Kimmel Center Meeting- Ilene's Group: April 14, 2008

Not like this

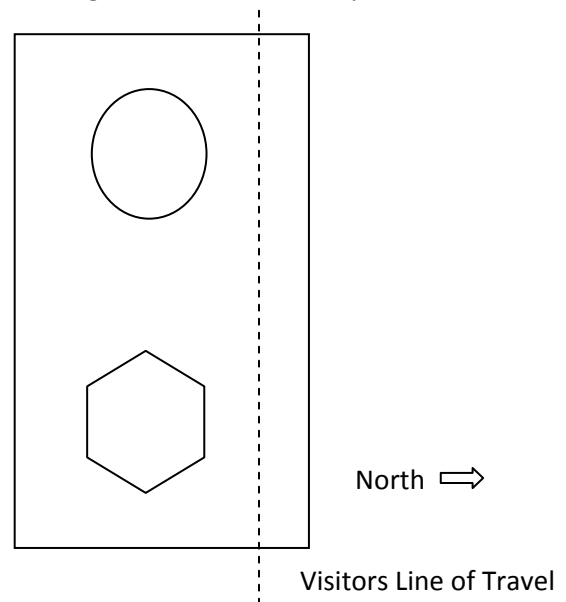
- Happy hour at the Kimmel Center. (\$4 wine) Would spread the word of how fun the Kimmel Center is, really fast.
- Need to create a buzz, that encourages word of mouth.
- Orient the plan vertically, having north read up is confusing from a visitors standpoint. The graphic should be drawn experientially.

Like this
